Well Name: BUDDHA TEMPLE COM	Well Location: T24N / R8W / SEC 30 / NENE / 36.290344 / -107.716049	County or Parish/State: SAN JUAN / NM
Well Number: 90	Type of Well: CONVENTIONAL GAS WELL	Allottee or Tribe Name:
Lease Number: NMNM54980	Unit or CA Name: BUDDHA TEMPLE	Unit or CA Number: NMNM94042
US Well Number: 300452923900S1	Operator: DUGAN PRODUCTION CORPORATION

Type of Submission: Notice of Intent	Type of Action: Plug and Abandonment
Date Sundry Submitted: 10/06/2025	Time Sundry Submitted: 03:40
Date proposed operation will begin: 10/17/2025

CONDITIONS OF APPROVAL

Notice of Intent – Plug and Abandonment

Planned P & A Wellbore Schematic

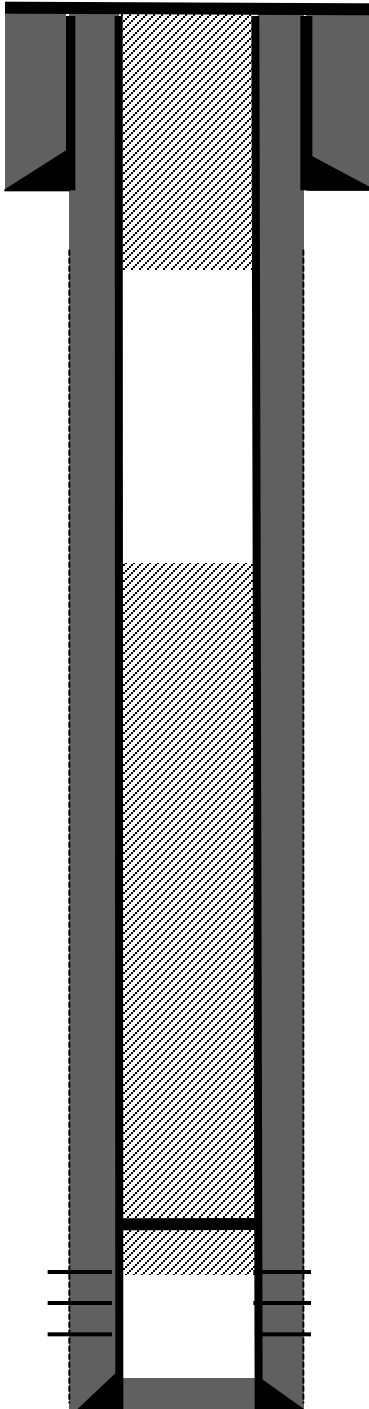
1. Plugging operations authorized are subject to the attached "General Requirements for Permanent Abandonment of Wells on Federal and Indian Lease."
2. The following modifications to your plugging program are to be made:
 - a. No changes to the procedure.
3. **Notification:** Farmington Office is to be notified at least 24 hours before the plugging operations commence at (505) 564 7750.

You are also required to place cement excesses per 4.2 and 4.4 of the attached General Requirements.
